Tottenham House and Estate

Design, Access and Heritage Statement

Pool House and Spa (Building 36)
Plant Room (Building 16a)

v3 / 2 June 2026

Figure 11 - Pool House Plan indicating location of proposed external Stair

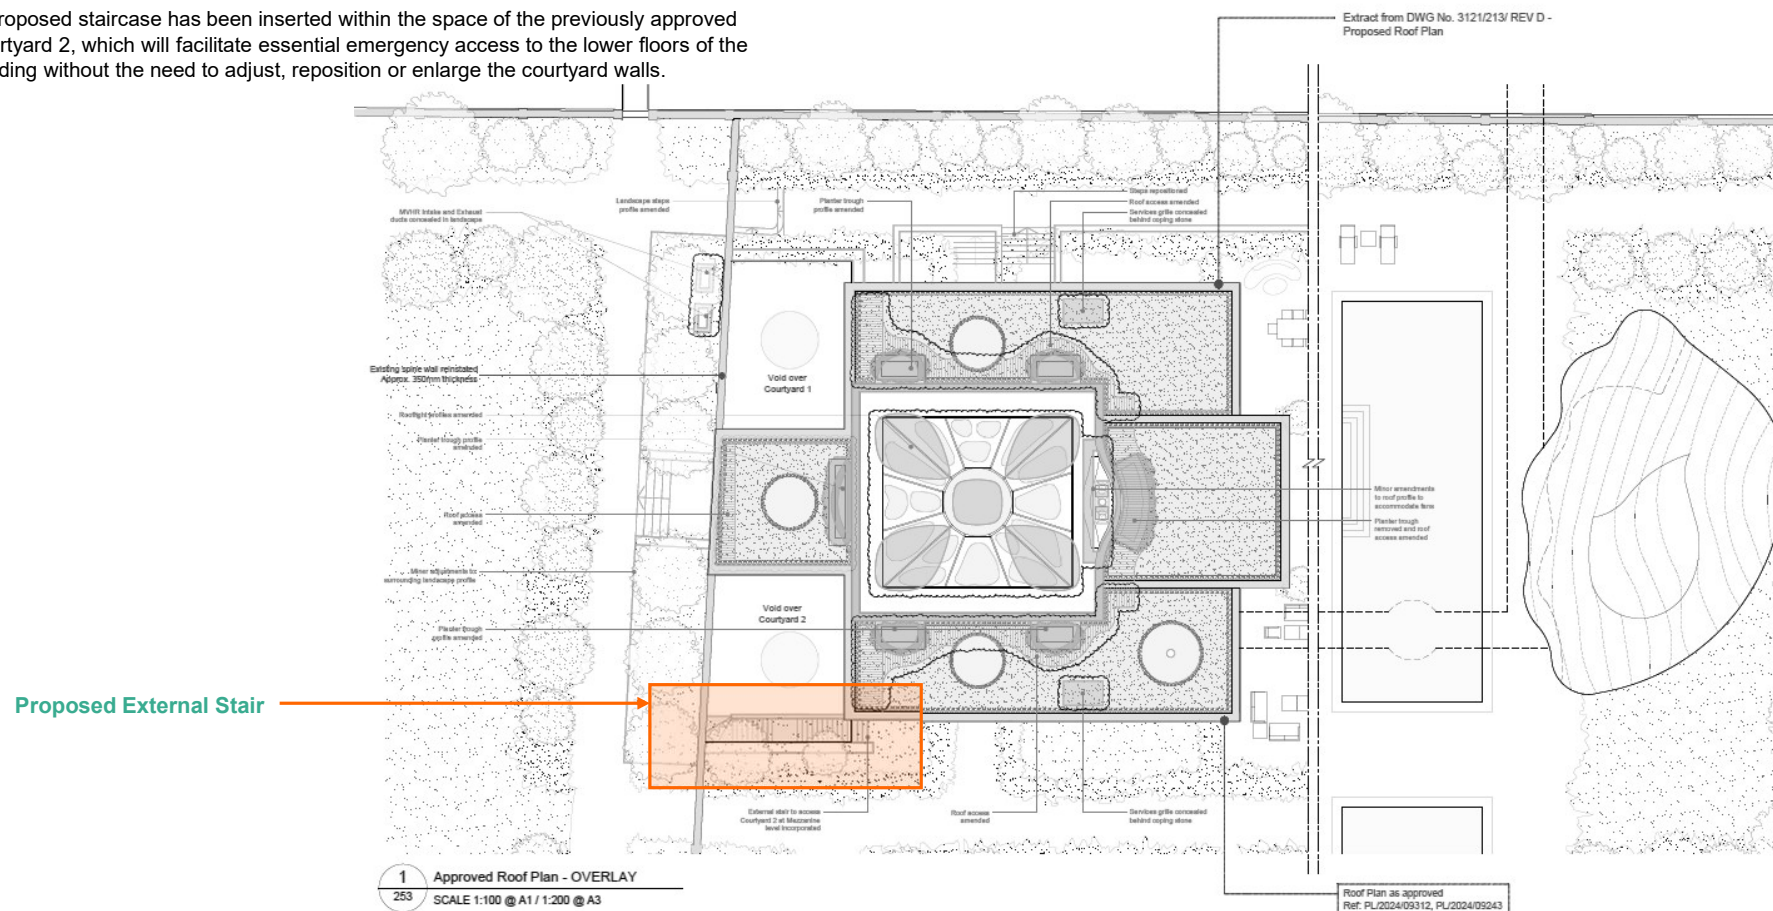
- 6.2 An external stair is required from ground floor to courtyard 2 at mezzanine level to provide access for fire services, and service maintenance to the gardens and the subterranean floors.
- 6.3 A proposed staircase has been inserted within the space of the previously approved courtyard 2, which will facilitate essential emergency access to the lower floors of the building without the need to adjust, reposition or enlarge the courtyard walls.

Figure 12 - Amended Access Door (Orange), Service Terminations (Blue)

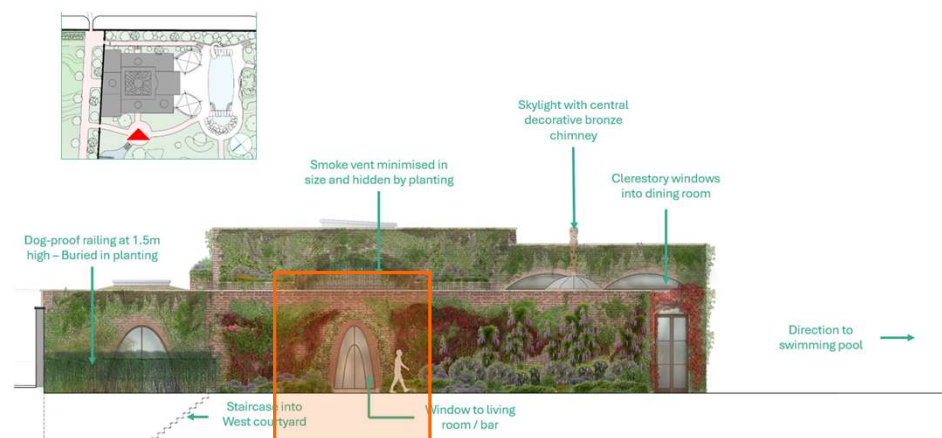
The principal entrance level door, which had previously been shown as a double leaf was amended to a single leaf, so it would be similar in proportion, and consistent in appearance to, the two flanking garden wall doors, and others timber doors in the walled garden.

6.5 To improve accessibility within the Pool House, internal floor levels within the stair hall were amended to create a flat, step-free means of escape for wheelchair users to the front door in the spine wall. Externally, the impact of this was to lower the level of the front door in the spine wall, and introduce a stepped entrance in the landscape.

6.7 Two further termination points have been shown on the North Elevation at ground level. These low-level grilles will be set deep within a 4m deep planted border, and as such will concealed them from view.

Figure 14 - East Elevation: Amended Fenestration / Eastern Access Door

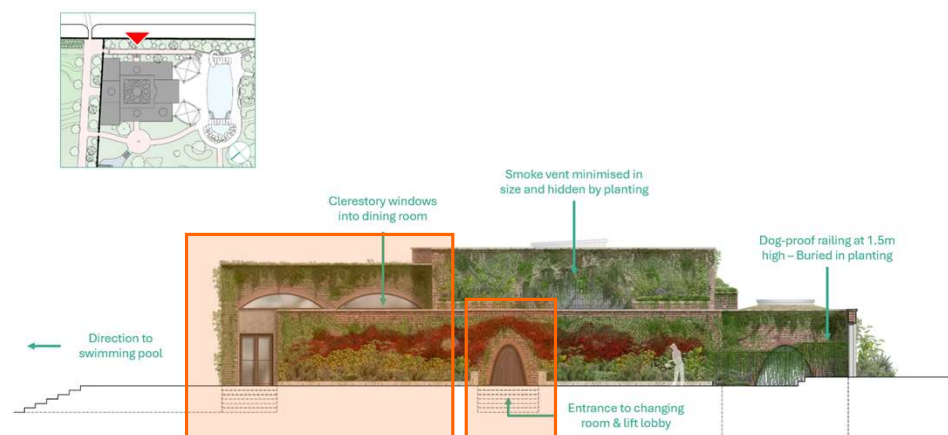
- 6.9 The single leaf French Doors in both the east and west elevations have been amended to double leaf doors, which improved the proportion of the elevation. The curved clerestory windows above the French doors have been adjusted to align with the door reveal.

- 6.10 Following a request to amend the internal layout of the Pool house, the position of the timber Eastern Access Door was adjusted, moving 2.9m to the south.

Figure 16 - West Elevation: Amended Fenestration

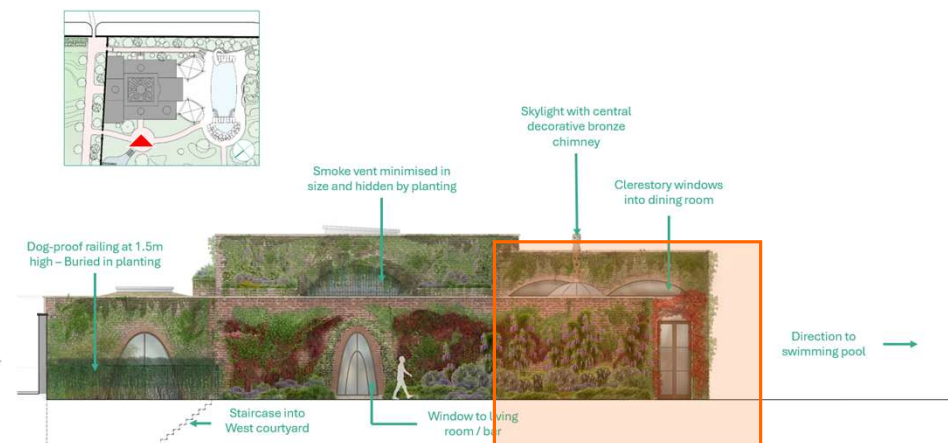
- 6.11 The proportions and glazing subdivisions of the French Doors of the South Elevation have been refined in the amended planning drawings to create a more harmonious and balanced composition. The flanking French doors have been vertically subdivided into three panes, and the taller doors to the gallery have been divided into four equal parts. The head of the smaller doors has been arranged to align with the third transom of the taller doors to achieve a cohesive geometric relationship across the whole façade.

Figure 17 - Amended Atrium Glazing (Orange), Planters (Green) and Service Terminations (Blue)

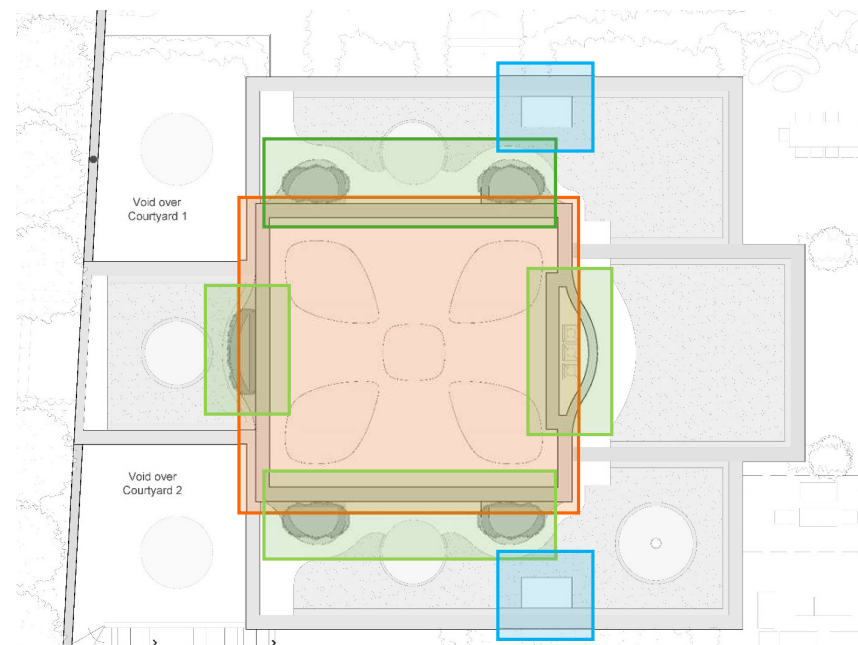
- 6.12 The approved roof plan featured a fully glazed, pyramidal roof set over the atrium below. The roof plan of the amended proposals has been rationalized, and the single glazed roof has been replaced with four larger organic, petal-shaped, rooflights arranged radially around a central rooflight.

- 6.13 The approved scheme included six planting containers built from solid brickwork, which would provide space for a growing medium to support climbing plants at high level. In the amended proposals, the southern planter closest to the flue terminals has been removed, and the shape of the remaining five planters has been designed with organic, curved forms.

- 6.14 The amended drawings identify the proposed air intake and exhaust terminals required to deliver the mechanical ventilation strategy. Two termination points are shown at roof level on the East and West sides of the roof. The ductwork cowlings will be concealed behind the parapet and coping stones.

Figure 18 - Amended Guarding (Orange), Copings (Blue)

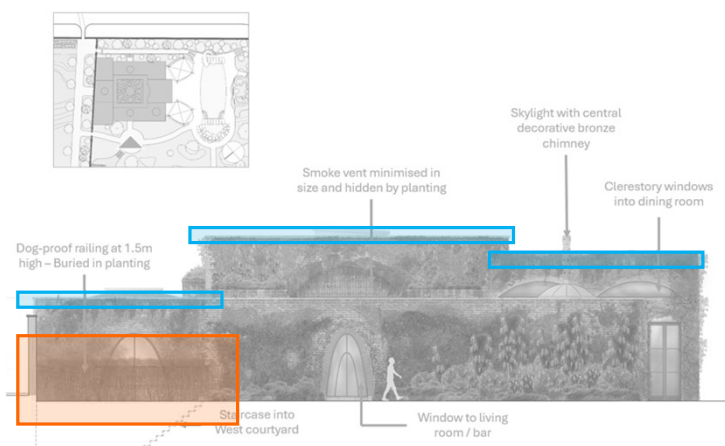
- 6.15 The historic existing coping stone profile for the Walled Garden has a once-weathered profile which has a 90mm face thickness. The coping stones in the approved planning drawings were drawn with a reduced thickness. In the amended drawings the coping thickness has increased to match the existing profile, which has been retained in places, and followed consistently throughout the repairs of the walled garden.

- 6.16 The guarding shown around the courtyards has been increased from 1.1m to 1.5m to provide increased protection from falling.

Figure 19 - Amended Spa Elevations

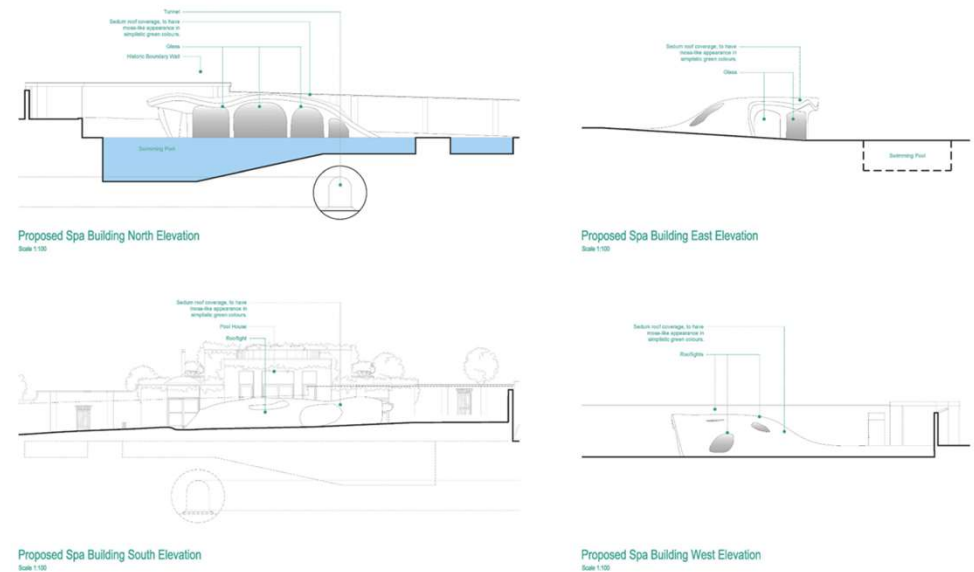
- 6.21 The proposed revisions to the Spa pavilion include:
- Simplification of the organic roof form by omission of a glazed projection that had formed a 'dormer' providing light to the main area of the building.

- Alterations to the roof construction to replace the metal roof with a green roof planted with a tailored vegetation layer - sedum or wildflowers - to further blend the pavilion with the surrounding landscape.

- Amendment to use a fine grained sprayed concrete finish rather than timber construction to provide structural support to green roof of the building.

- Minor adjustments to the outline of the main façade of the Spa pavilion to integrate the entrance with the staircase and tunnel, whilst retaining the proposed elevations tripartite glazed facade.

- Amendment to proposed finished floor level (FFL) of the pavilion, raised to the level of the surrounding swimming pool and Pool House.
 - Amendment to the roof form to keeping the building below the level of the adjacent Walled Garden historic walls, despite the amendment to internal floor levels.

Figure 21 - Proposed Extension to Building 16a housing condensers

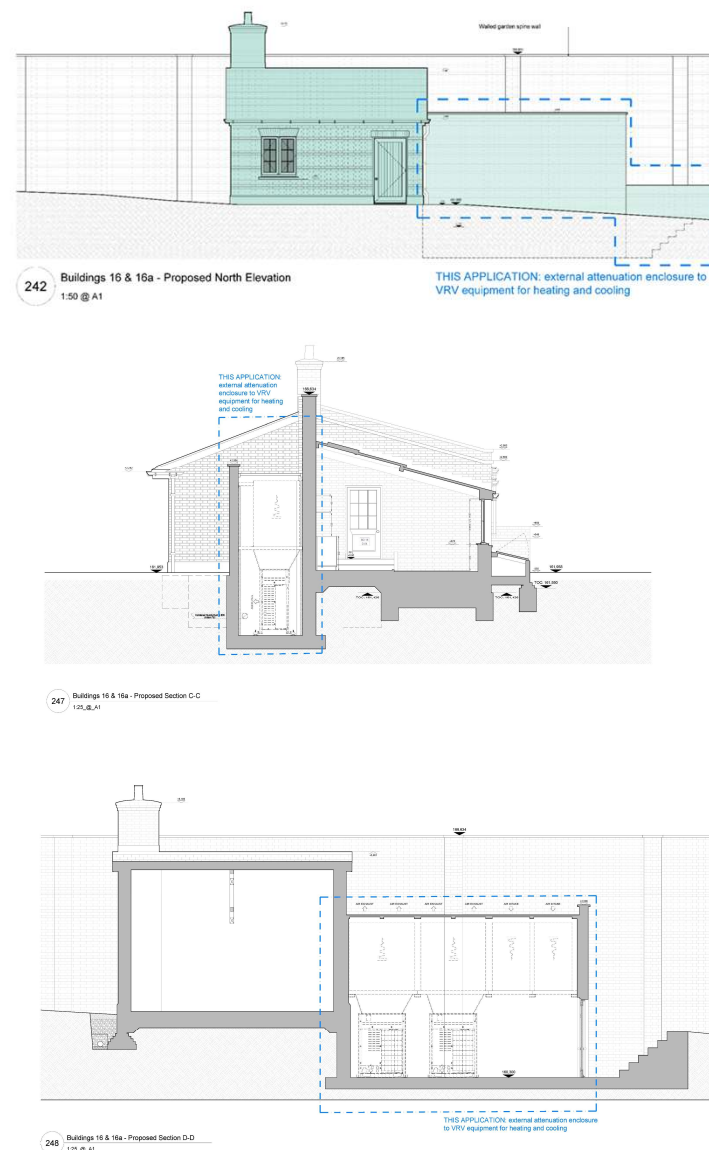
- 7.1 Building 16a was described as a plant room in the consented application serving the surrounding historic buildings within the walled garden.
- 7.2 The amended proposals for Building 16a are for a side extension which will house a proposed plant room / condenser enclosure for the Pool House (Building 36) .

- 7.7 To resolve the issue, an alternative proposal was developed, where the Pool House condensers would be located inside a purpose designed enclosure that can be open to the air, whilst also providing full acoustic insulation and attenuation.

- 7.8 The condenser enclosure was conceived as a simple brick building with a lowered internal floor, and sufficient internal space for the condensers and acoustic attenuators. The airflow required by the mechanical equipment would all be provided through a layer of mesh at roof level, concealed behind the parapet, rather than through large louvred panels in the walls that would be incongruous in this historic environment.

- 7.9 Within the context of the historic walled garden, Building 16a, is a relatively simple and utilitarian building. The proposed condenser enclosure will read as a modest brick extension to Building 16a, accessed only by a simple timber door.
